ADDENDUM #2
CITY HALL REMODEL
BID # 20/21-008 / PWP # WA-2021-135
BIDS DUE NO LATER THAN: 1:45 PM ON FEBRUARY 17, 2021 - REVISED
PUBLIC BID OPENING: 2:00 PM ON FEBRUARY 17, 2021 - REVISED

This addendum is to notify all potential proposers of clarifications made to the Bid documents as stated below.

RFI Questions and Answers:

CLERK/CUSTOMER SERVICE - PLANS, SECTIONS, ELEVATIONS

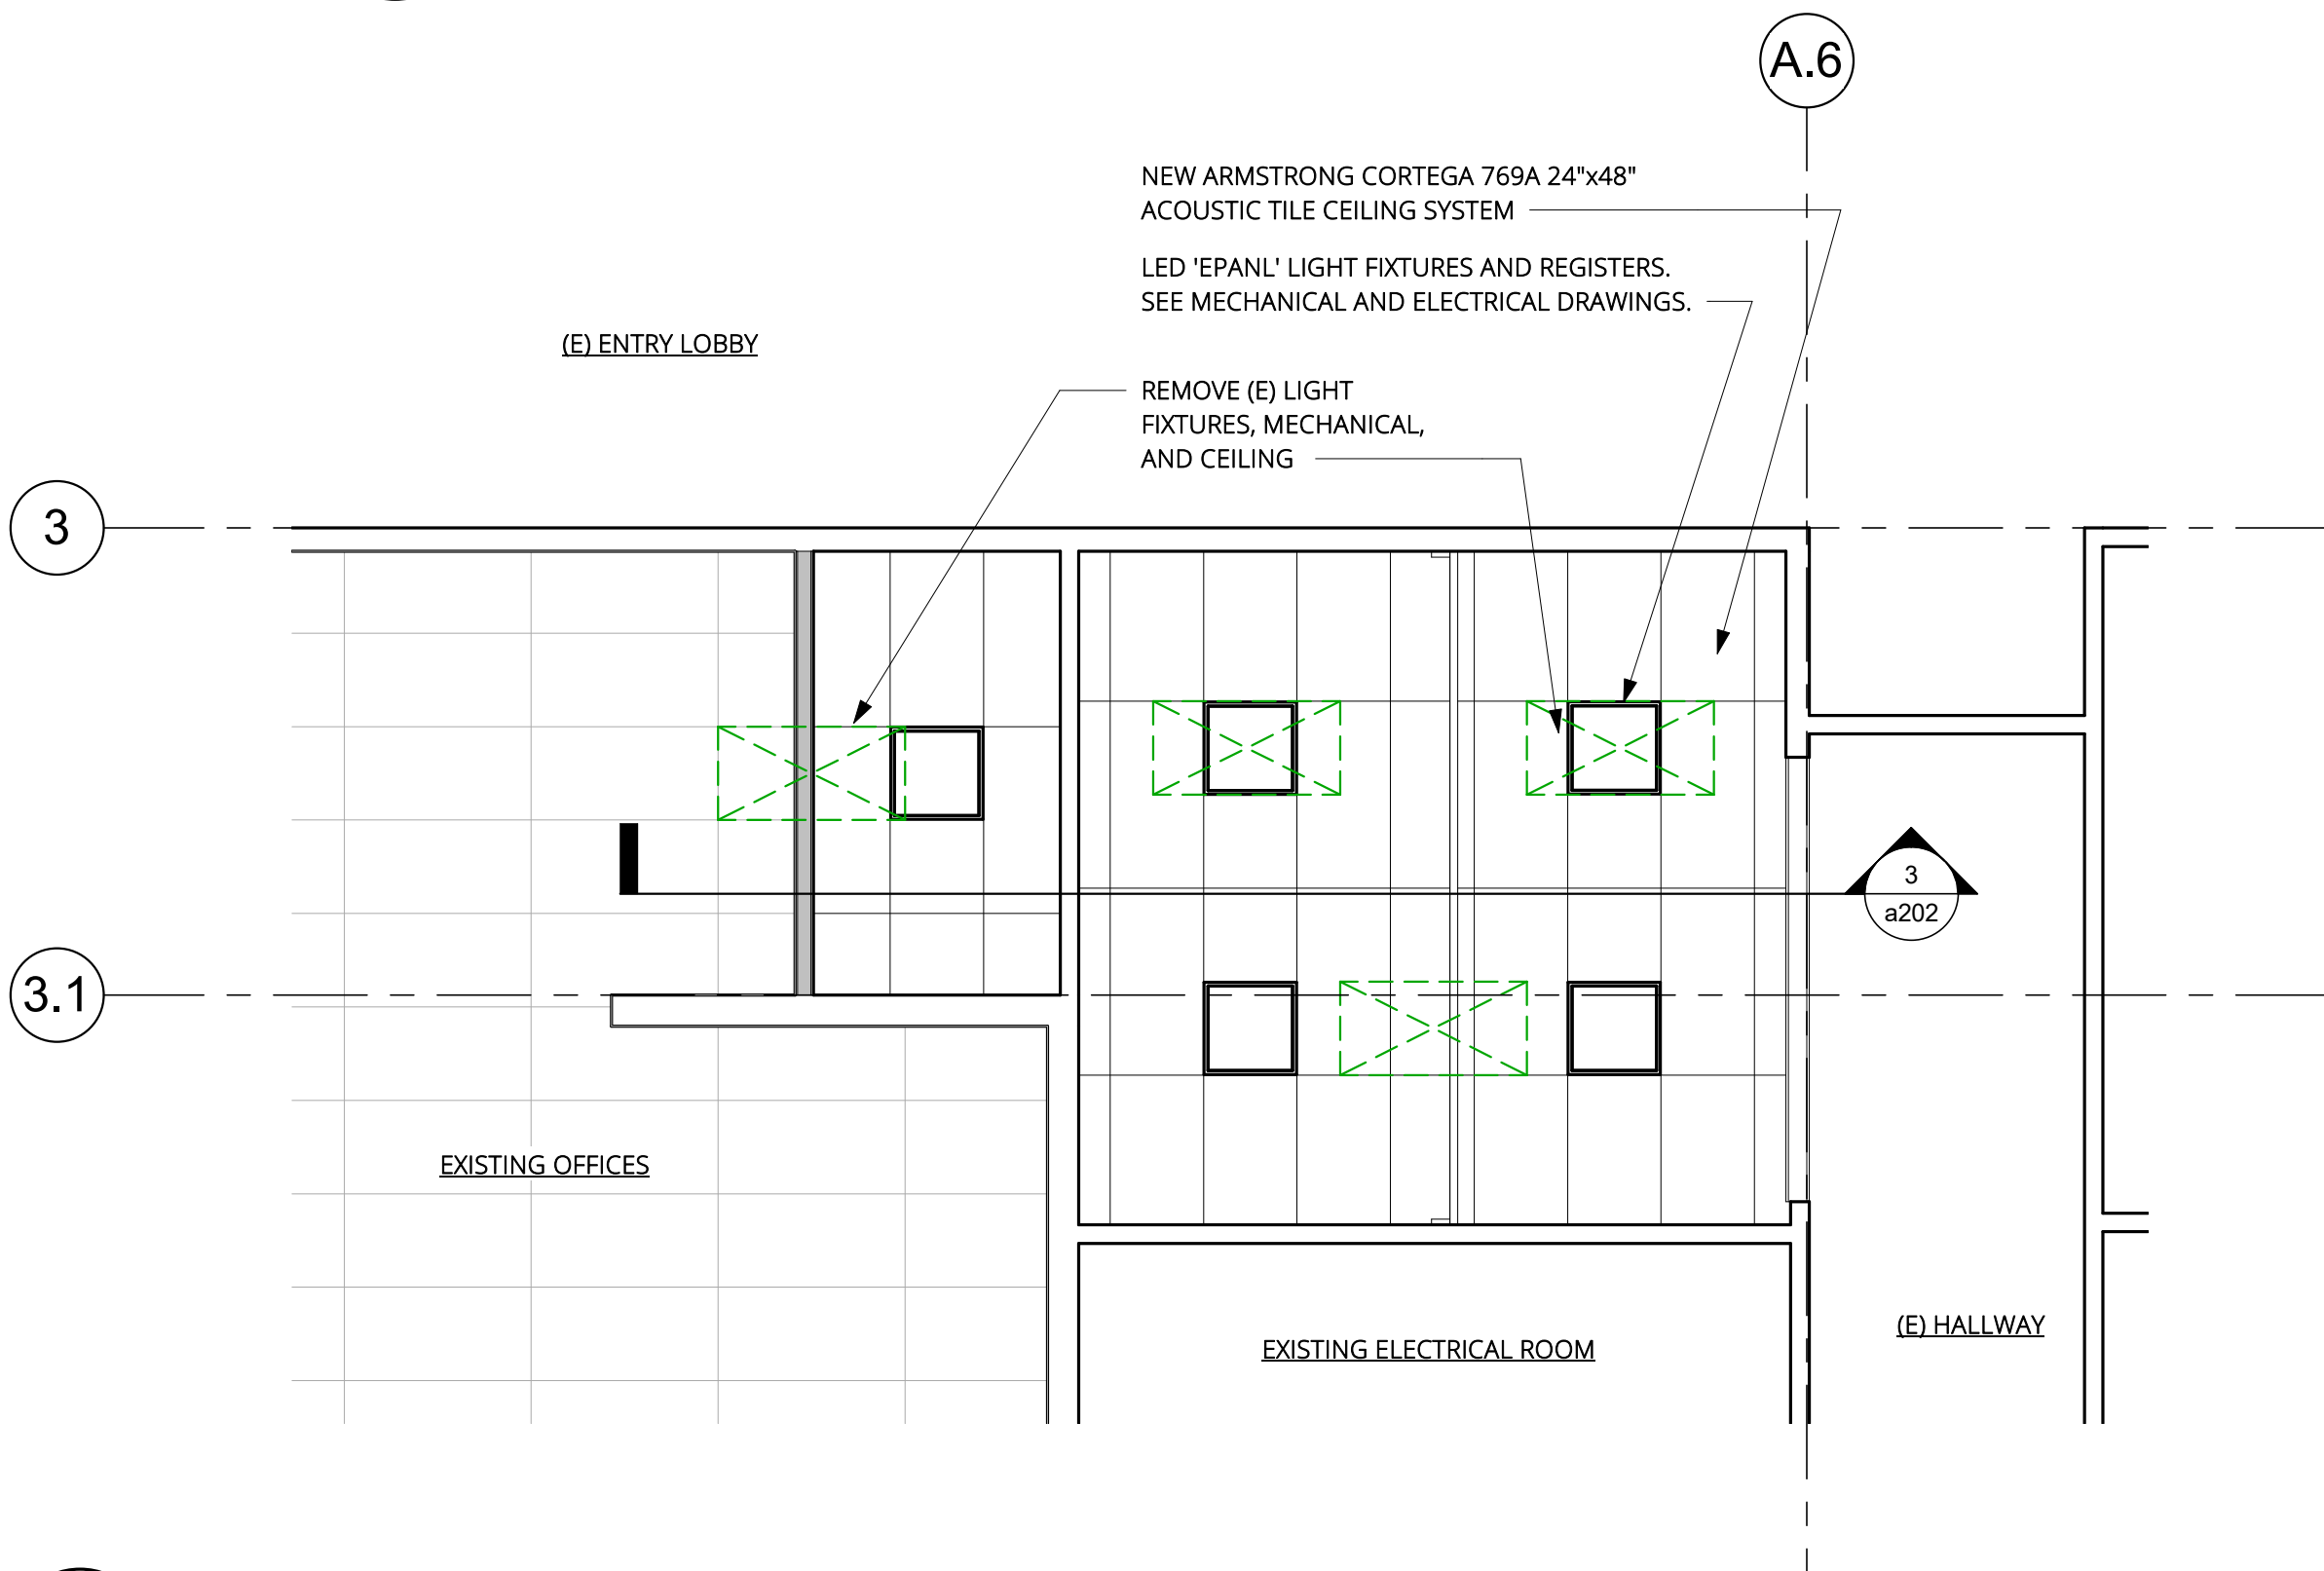
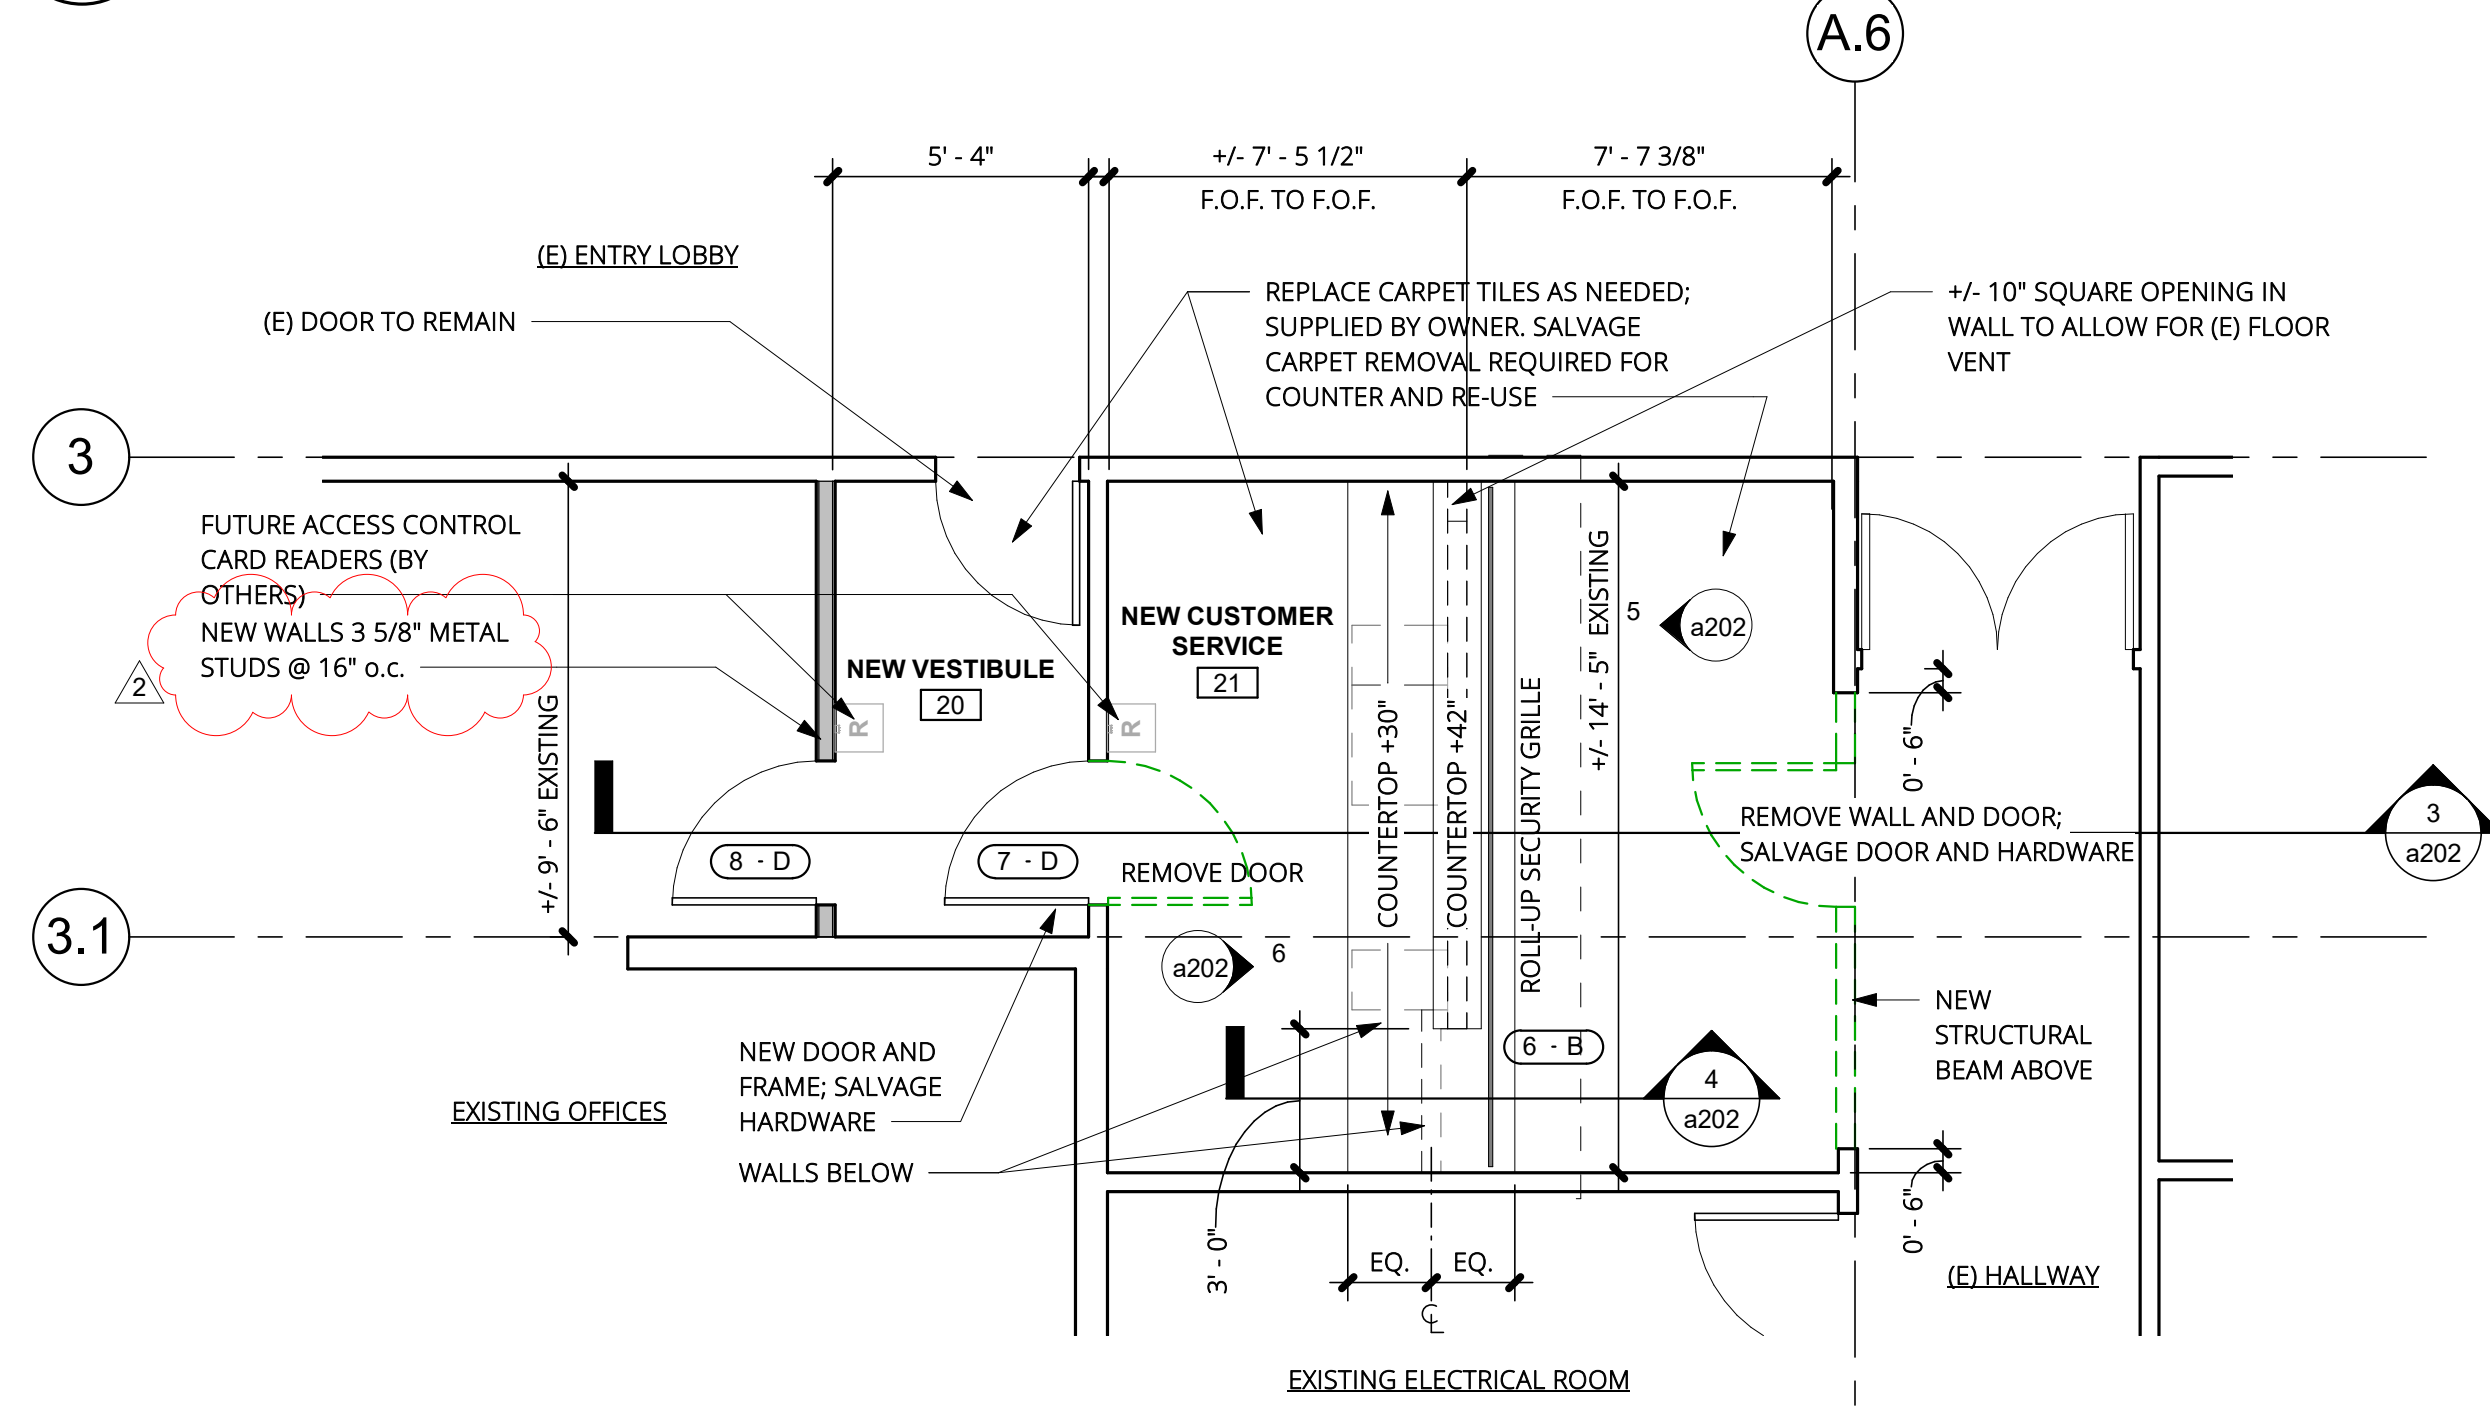
- c) Please provide specifications for the roll-up security grille and counter tops / casework?
 - i) **Answer:** The roll-up security door shall be an “Overhead Door Company RapidGrille AP 676 Security Grille or equal”. This has been noted on the attached revised plan sheet A202. The countertops shall be Wilsonart Solid Surface or equal. The cabinets/casework shall be Wilsonart “Compact Laminate” high pressure solid

- d) On Sheet a202, the new wall in New Vestibule #20 calls to be 3 5/8" metal studs. The same wall on Sheet S-1 calls to be 2"x6" wood studs. Please clarify. Wood Studs to match Existing.

On Sheet a202, is the new wall on column line A.6 to be a wood stud wall or a metal stud wall per the Wall Legend.

- g) Sheet a202, Plan Note #7 calls for "Directional Signs". There are no signs of any type shown on the drawings. Will any signage be required for this project? Same note appears as note #6 on sheet a204 and #7 on sheet a205.

composite or equal. All cabinets and hardware shall be commercial grade or higher and owner shall select final colors and finishes during the submittal process.

- i) **Answer:** All new walls shall be constructed of 20 gauge 3 5/8" metal studs unless noted otherwise. All references to wood studs have been updated on the attached plans to reference metal studs. See attached revised plans.

- i) **Answer:** All signs will be provided and installed by others.
- h) Is the intent to provide new acoustical ceiling grid in the ceilings shown on sheet a201, a,202 and a204? The Reflected Ceiling Plan on sheet a205 specifically calls for the existing acoustic tile grid to remain. Please clarify.
